STAFF REPORT AMENDED 2-23-84  
CITY PLANNING COMMISSION

- APPLICATION:
1. Variance to locate three of the 11 required parking spaces off site (Sec. 6-A-10)
  2. Variance to allow substandard parking configuration (Sec. 6-C-1)

LOCATION: 924 'F' Street and 917 'G' Street

PROPOSAL: The applicant is requesting the necessary entitlements to allow for the construction of a 3,200 square foot addition to an existing 1,200 square foot office building.

# EXHIBIT G

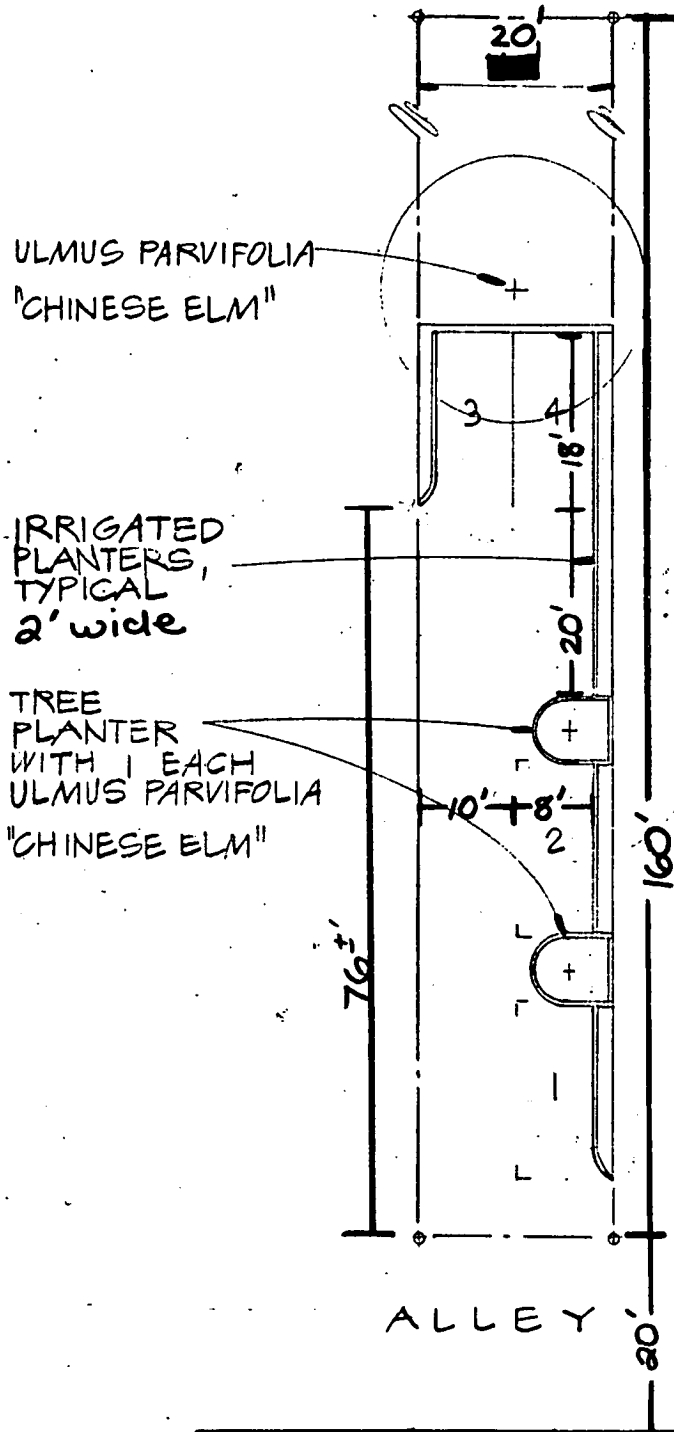
- a. Traffic Engineering
    - 1) Vehicles entering stall No. 2 would have to move sideways to get into stall. The plan provides no backing room;
    - 2) On-street parking uses 19 feet from face of curb to first lane line with 7.5'/8.0' stall width. Drivers often use part of second lane to back into stalls. This plan only has 18 feet left for stall and aisle after subtracting the planter width. That leaves 10 foot aisle and eight foot stall;

- 4) Recommend denial of the project. Lot size and parking lot design is inadequate for 927 'F' Street.
  - c. Alkali Flat PAC

3. Both of the proposed parking areas have substandard parking spaces. At the 917 'G' Street site the three compact spaces adjacent to the alley do not have the required 25-foot maneuvering width. The proposed parking lot at 924 'F' Street has several problems as previously noted by the Traffic Engineering Division. Stall No. 2 will be especially difficult to maneuver in and out of due to the location of the adjacent planters and width of the adjacent aisle. Stalls No. 3 and No. 4 will require a vehicle to back out approximately 76 feet along a 10-foot wide aisle before reaching the alley. Stall No. 4 only has 20 feet of maneuvering width directly behind it, requiring a vehicle to maneuver in and out of the stall at an angle.
